Nye County

**Nye County Comments on NUREG-1768, Package Performance Study Test
Protocols, Draft Report for Comment**

NYE COUNTY COMMENTS ON PACKAGE PERFORMANCE STUDY TEST PROTOCOLS

NUREG-1768 DRAFT REPORT FOR COMMENT

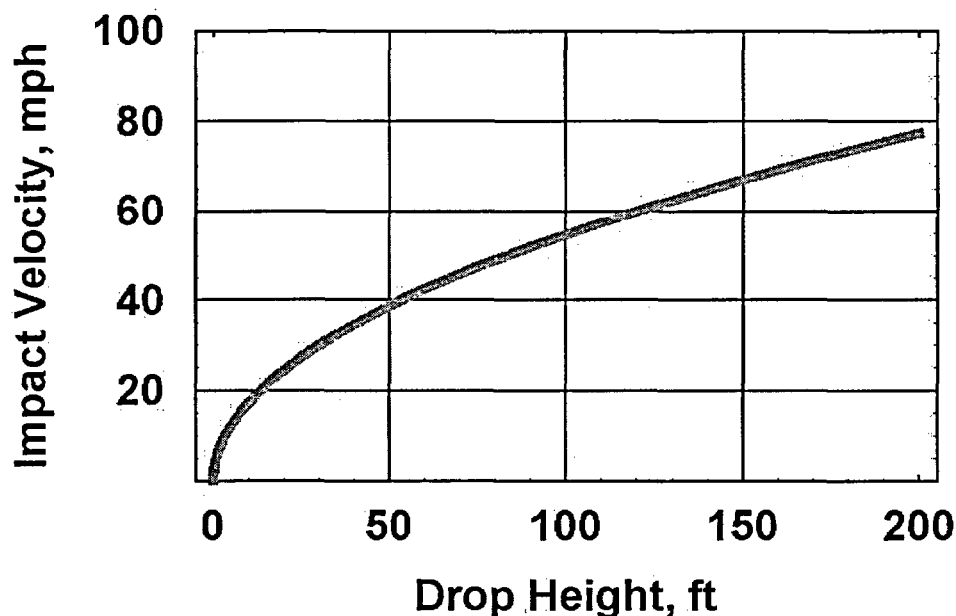
The tests should be conducted horizontally. If conducted as drops from a tower, however, the Test Protocols should be revised to clearly indicate that the test will be conducted from a height greater than 9 m (30 ft), and should indeed disclose the actual height of the drops proposed.

NUREG -1768, at p. 1, cites the current cask certification requirement for a 9 meter (approximately 30 ft) drop onto an unyielding surface, but does not at the same time make clear that such a drop is not proposed (or is

considered inadequate) for the PPS. Later, at p. 9, the document says that a "new drop tower might be high enough to allow an 82.3 m (270 ft.) free drop of a 136,000 kg (300,000 test unit---)." This is heartening, but it should be made very clear in the NUREG itself that the test will be conducted at a height greater than 30 feet. If a 270 foot tower is to be constructed than why not say at the outset that the drop will be from 270 feet? Clearly, a 30 foot drop test will not produce adequate results, because it does not simulate a worst case scenario at highway or rail speeds. Such a test would yield an impact velocity of approximately 30 mph, well below highway speeds.

We provide a simple example. A truck is traveling down the highway and hits an icy spot in the road. The driver loses control because of a driving error by the driver of the vehicle that is passing him/her at the time. The truck jackknifes and flips. The cask impacts directly on a bridge abutment or rock outcrop along the highway. The load on the cask may not be evenly distributed (point load), the mass of the truck trailer behind the cask may increase the impact forces, and the impact velocity may exceed the impact velocity from the 30 foot drop test. The relationship between height in the drop test and impact velocity (ignoring air resistance) is illustrated in the figure below.

The NUREG itself should provide no opportunity for any confusion on this. It should very explicitly state that the current cask certification requirement of a 9 m or 30 ft drop will not be employed, and should set out specifically the height to be used.
